UNITED STATES PATENT AND TRADEMARK OFFICE

APPLICATION NO.	FILING DATE	FIRST NAMED INVENTOR	ATTORNEY DOCKET NO.	CONFIRMATION NO.
09/321,633	05/28/1999	JAMES W. KENNEY	E-1901	6762

**Office Action Summary**

## DETAILED ACTION

FIG. 20

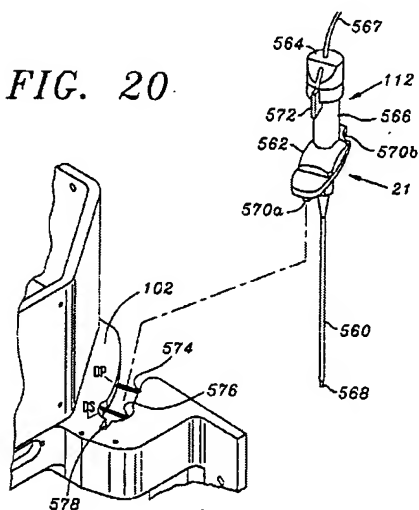
Additionally, this switch, through the microprocessor 43, automatically activates/deactivates the air pressure source. Kenney fails to teach a gun holster arranged to support the gun above the worktable. Goodale *et al* teach a pipette holster used to support the pipette 112 above a work table in a vertical direction. Goodale *et al* teach a mounting bracket 102 having a fork with prongs 574 and a circular socket 576 constructed to removably hold the pipette. Wherein the socket is formed between the prong and has a diameter (DS) which is larger than the distance between the prongs (DP), (column 11, line 61- column 12, line 28, and modified Fig. 20 below.) Such use of a bracket insures that the pipette tube does not touch anything and will remain sterile.
